**Re: DA-2356-00 West Centertech – Site Plan  
Comment Response Letter #2**

SITE PLAN  
WEST CENTERTECH

WEST CENTERTECH	
SITE ADDRESS:	16001 E. LOCKHEED DRIVE AURORA, CO 80011
PREPARED FOR:	WEST CENTERTECH, LLC PO BOX 472918 AURORA, CO 80047

COVER SHEET

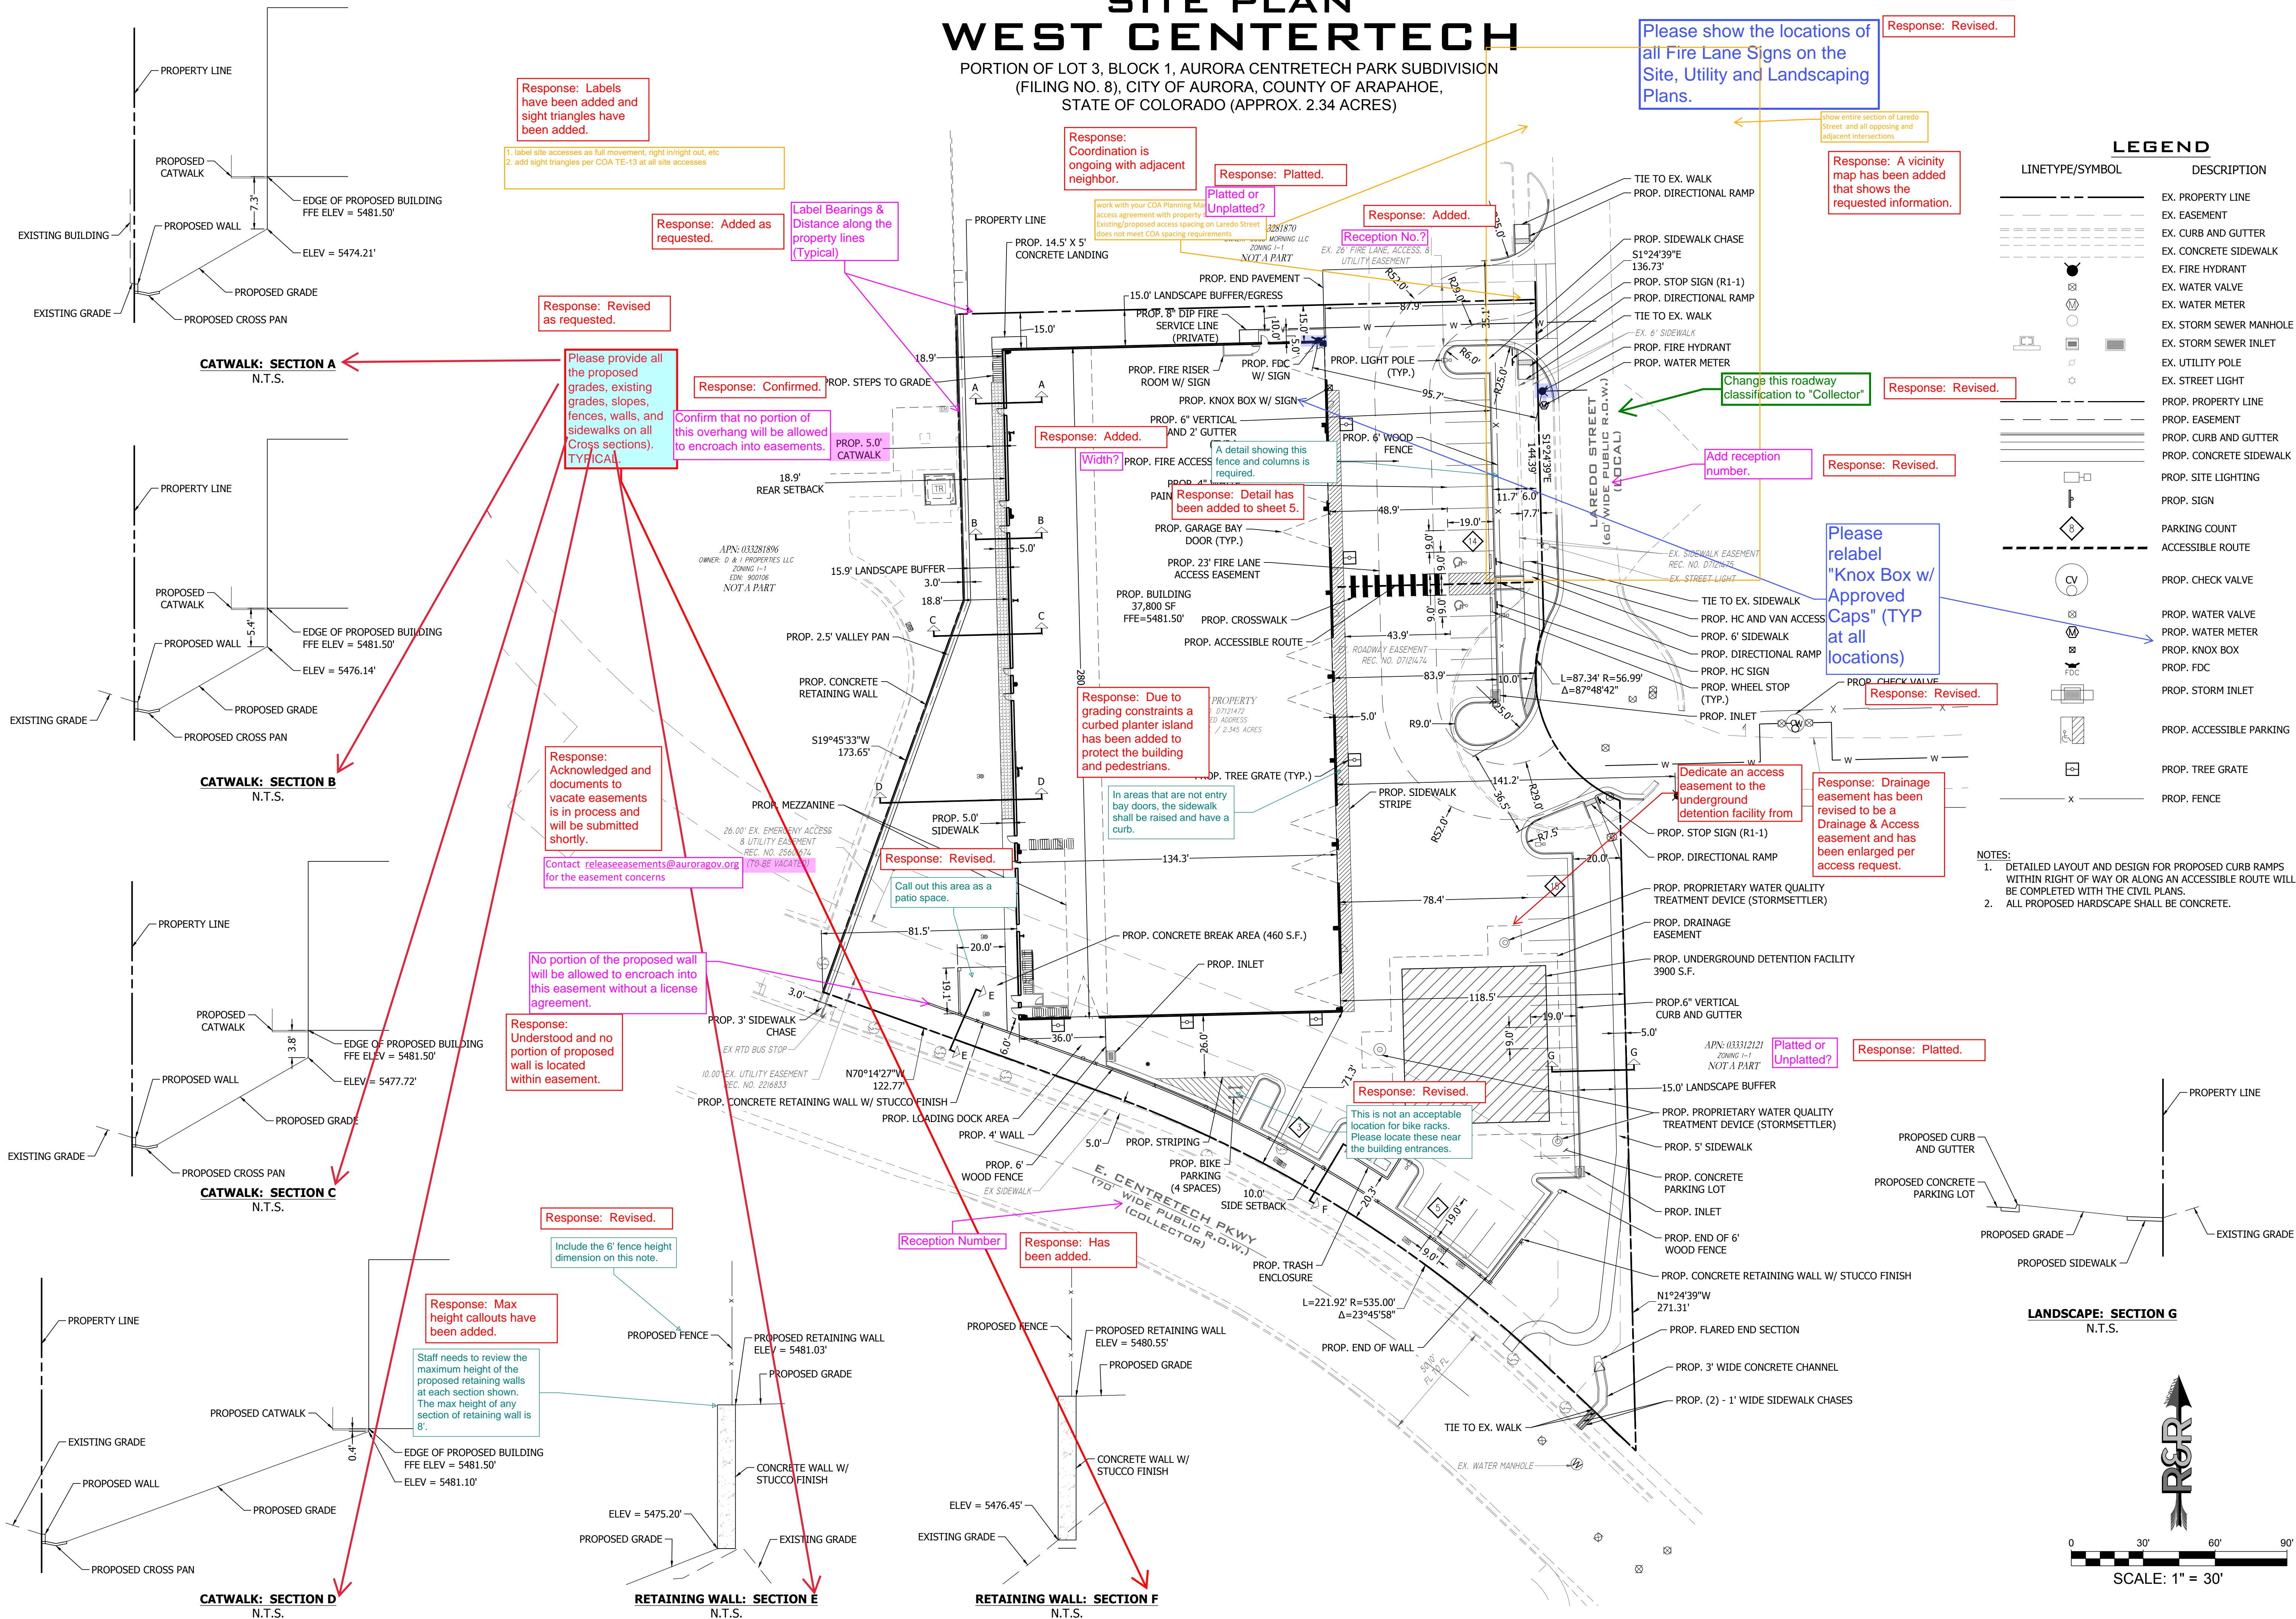
Coordinate with the development to the north to ensure this parcel is replatted per the property lines shown on this plan.

The site plan will not be approved by Aurora Water until the preliminary drainage letter/report is approved.

Repeat comment: Include a Site Plan Details sheet to include the following:  
-Fencing  
-Retaining Walls  
-Trash Enclosure  
-Bike Racks  
-Signs requested by Fire/Life Safety

Updated Traffic Study not provided. Site Plan will not be approved until Traffic Study is approved

Provide contact information for the applicant and all consultants on the cover sheet.

If it's an adjustment to City requirements outside of the UDO (Chapter 146), remove it from the site plan. This is requested through Public Works and Aurora Water.

Response: Coordination is ongoing and a replat is in process.

Response: Understood. Signature sets of the PDR have been requested.

Response: Requested details have been added and are provided on the appropriate sheets.

Response: Updated traffic study has been provided.

Response: Provided on the left side of the cover sheet.

Response: Acknowledged and has been removed.

**UTILITY PLAN**  
NO.  
**3 OF 13**

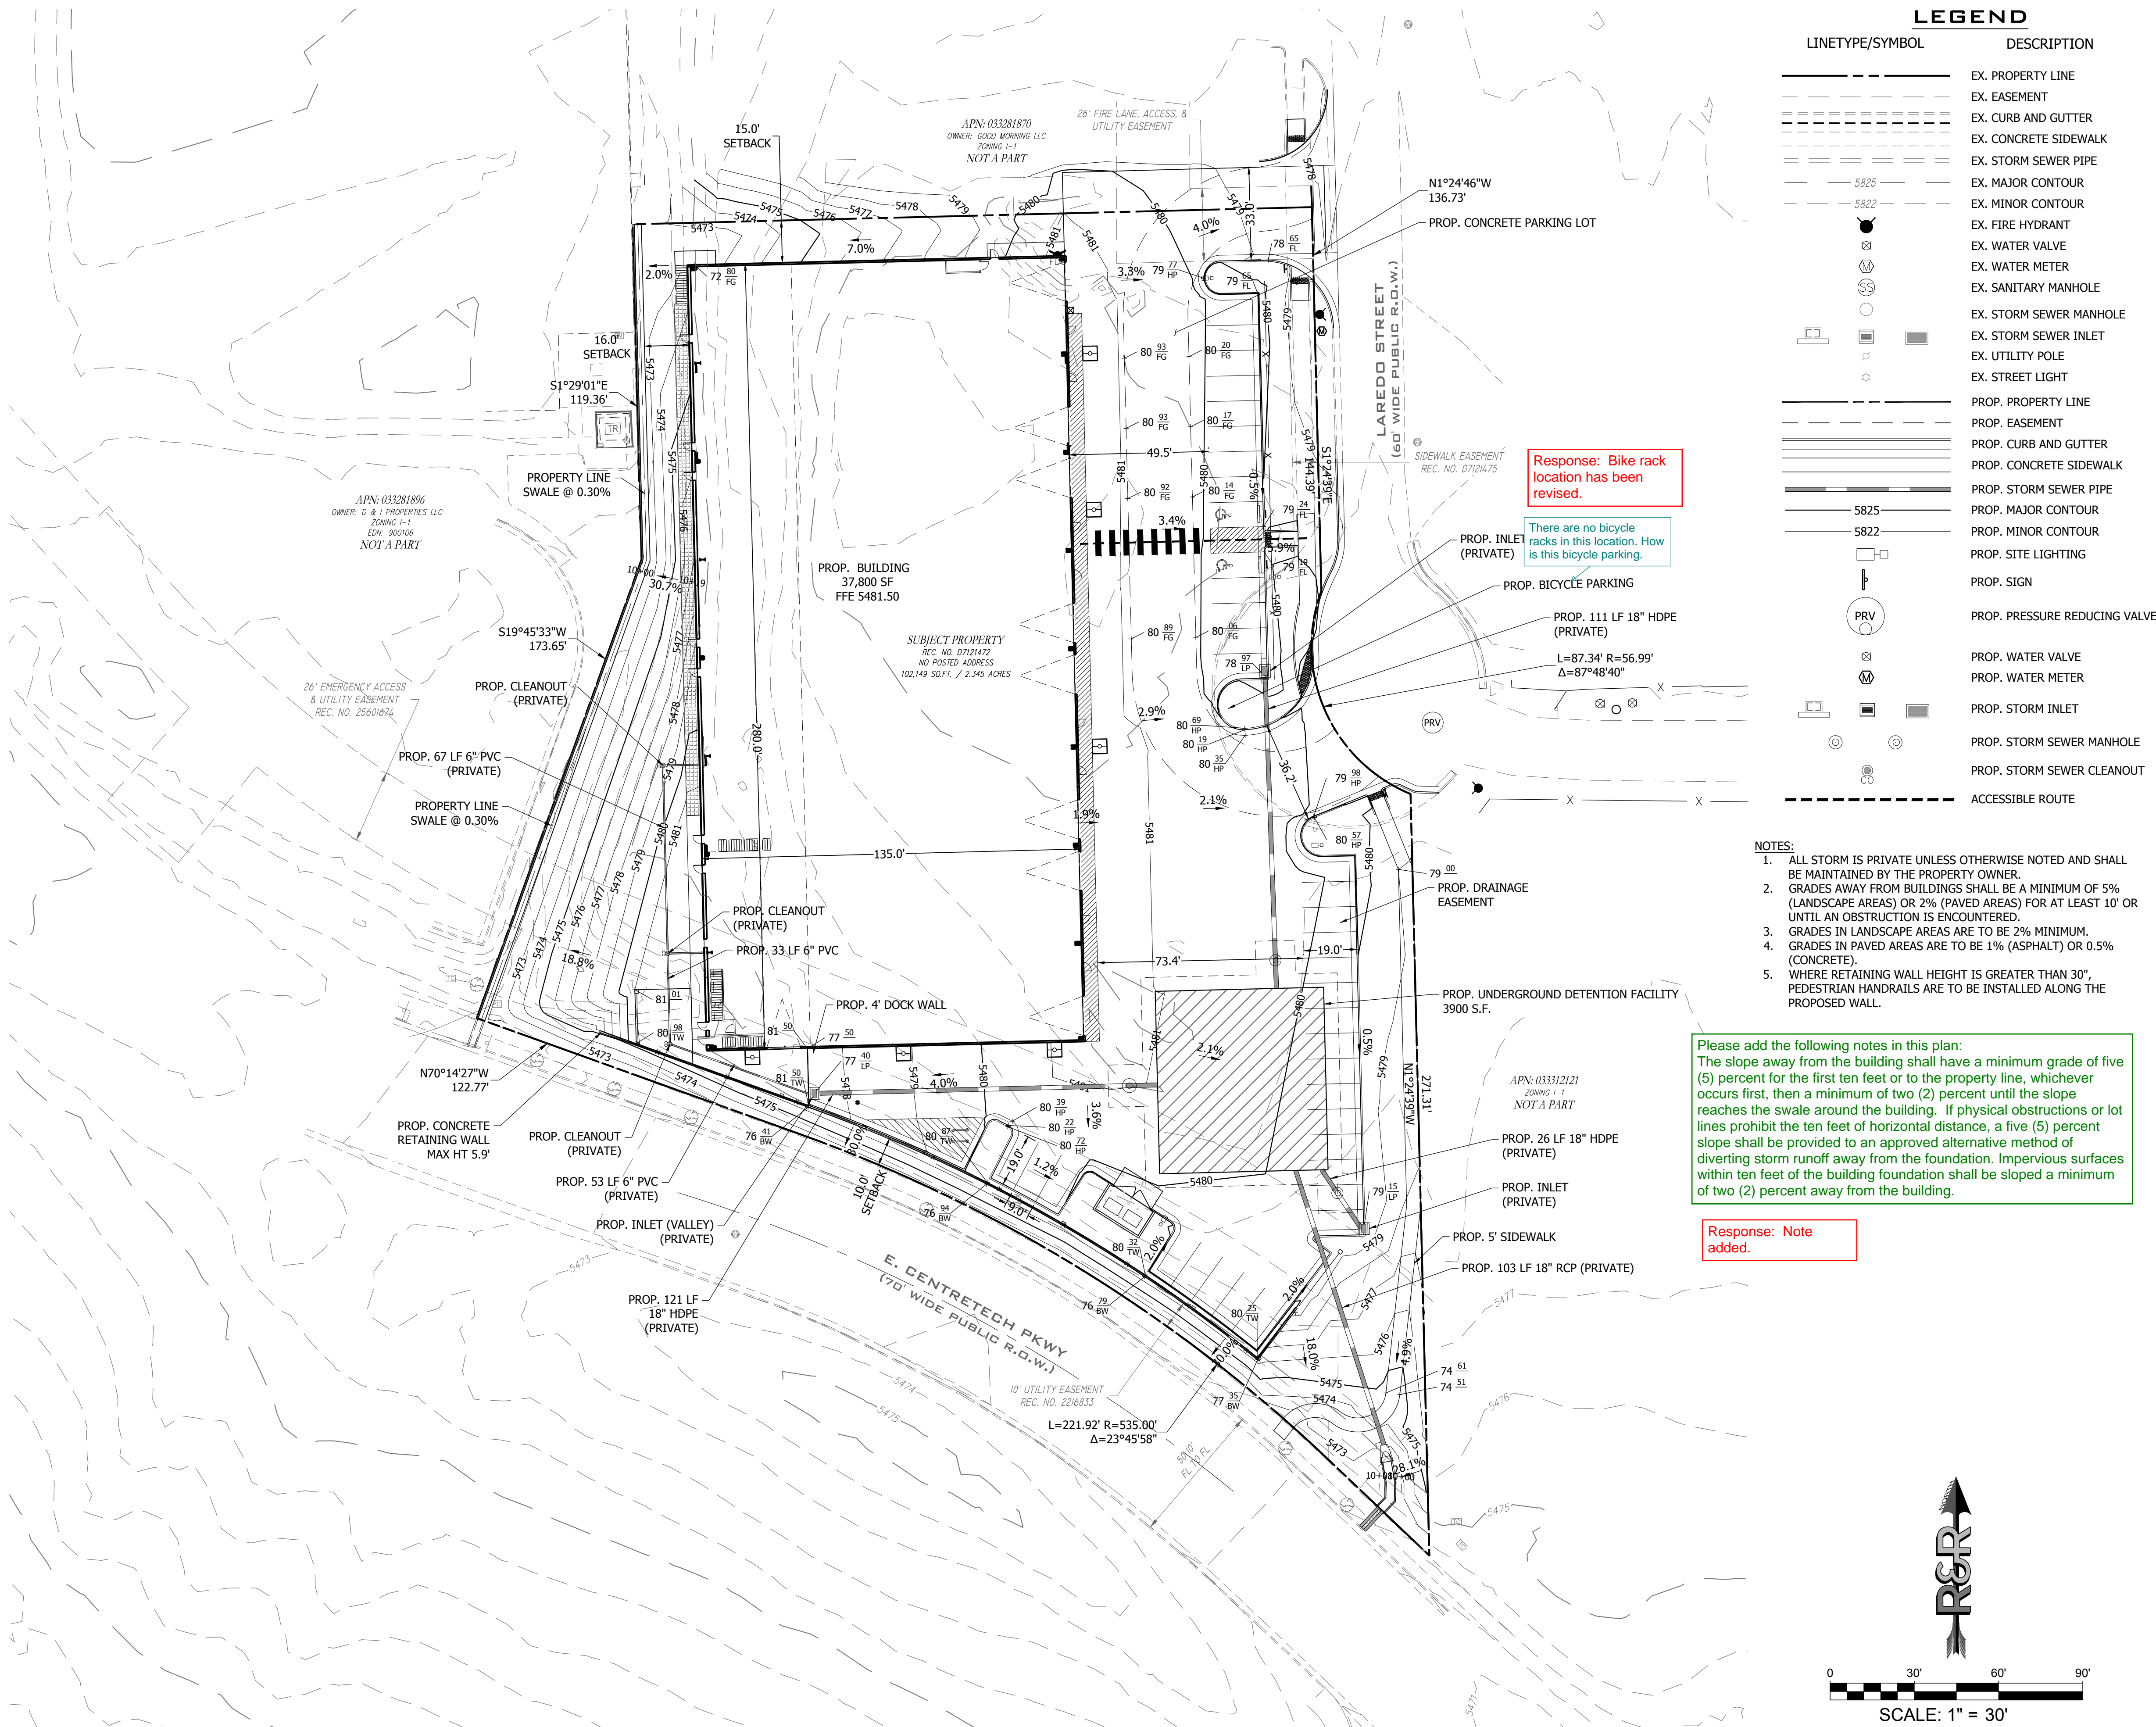
Please show the locations of  
all Fire Lane Signs on the  
Site, Utility and Landscaping  
Plans.

Advisory for upcoming Civil Plan  
review: soil resistivity test shall be  
performed and results shown on  
the civil plan to determine the  
appropriate fire line material. DIP  
shall not be allowed for soil  
resistivity < 1000 Ohm-cm

Please obtain  
approval from  
Traffic for the  
required backup  
area.

Indicate that this water main extension will  
be within a ROW. Otherwise, a water  
easement shall be dedicated

Response: Added.

Response: Soil test is  
ongoing and prior to  
construction the and  
CD approval  
appropriate material  
will be selected for  
approval.

Response: A 5'  
hammerhead/back out  
area has been  
provided. Multiple  
attempts via email and  
phone were made to  
the Traffic Reviewer to  
coordinate and no  
response was  
obtained.

Response: Water  
main extension will be  
within ROW.

Response: Sanitary  
service line location  
and alignment has  
been revised.
